ERCOT Permian Basin Reliability Plan Study - Addendum

September 2024

Addendum

Figure 1.2: Modified 345-kV Import Paths in 2038

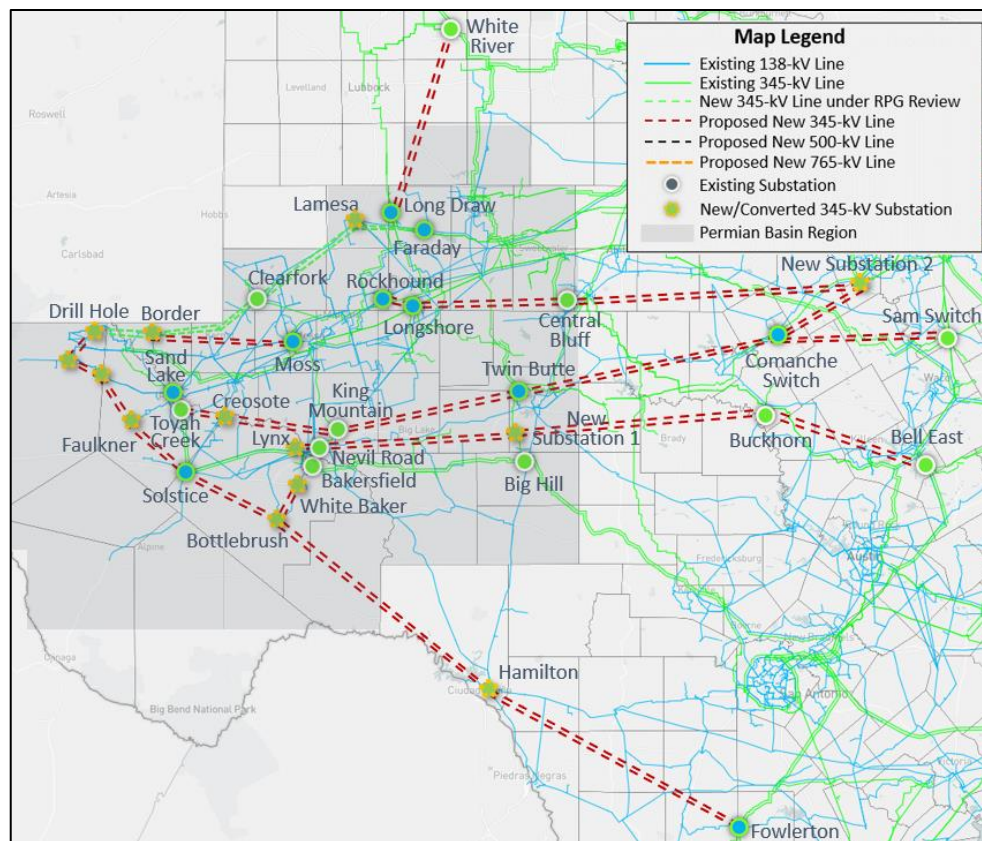
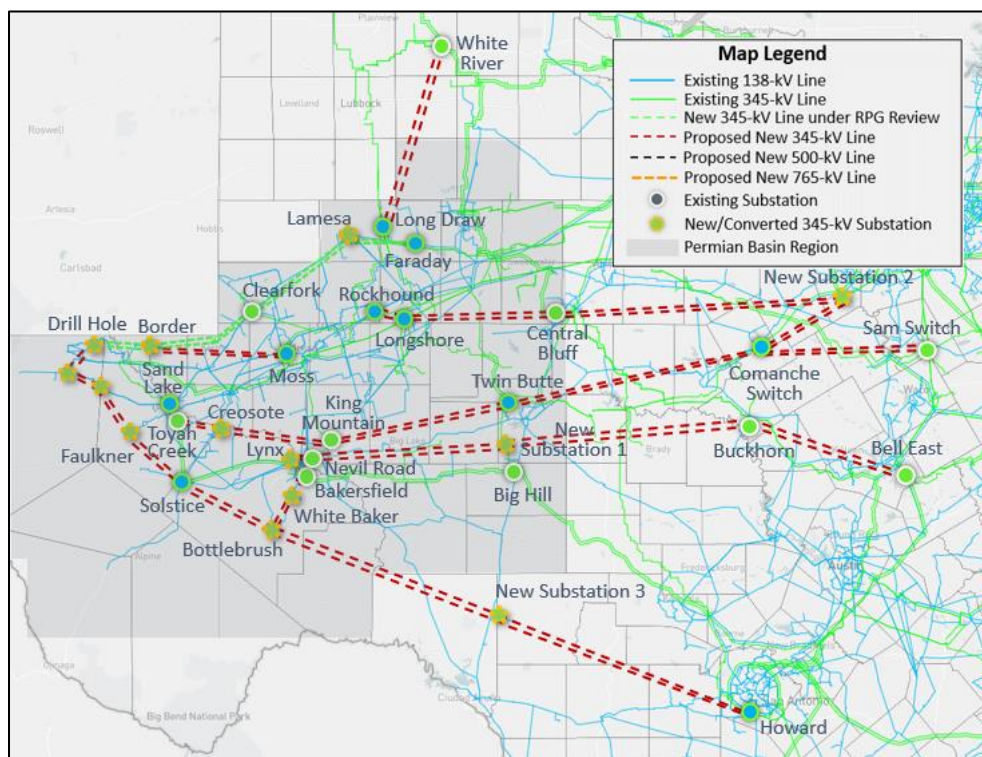
ERCOT is submitting this addendum to the Reliability Plan for the Permian Basin Region to change the recommended endpoint of one of the 345-kV import paths, Import Path 4. Specifically, ERCOT now recommends that this Import Path 4 should terminate at Howard 345-kV instead of Fowlerton 345-kV. This change will require the addition of a new 345-kV substation—"New Substation 3"—in place of the proposed new Hamilton 345-kV substation. ERCOT is recommending this change to the endpoint of Import Path 4 to better accommodate the changing load and generation patterns across the larger system, as identified in the initial 2024 Regional Transmission Plan (RTP). ERCOT has conducted additional reliability assessments consistent with the methodology identified in the Permian Basin Reliability Plan Study and confirmed that the proposed new endpoint to Import Path 4 meets the overall reliability need and performance of the 345-kV import path in the Permian Basin Reliability Plan Study. Figure 1.1 shows the original proposed 345-kV import paths for 2038, and Figure 1.2 shows the modified 345-kV import paths for 2038.

Modified Import Path 4:

- Construct a new 345-kV "New Substation 3" substation. Add new dynamic reactive devices (350 MVar) at New Substation 3 345-kV substation; and
- Add new Howard – New Substation 3 – Bottlebrush – Solstice 345-kV double-circuit lines with a normal and emergency rating of at least 2988 MVA per circuit. This will require approximately 370 miles of new right of way (ROW).
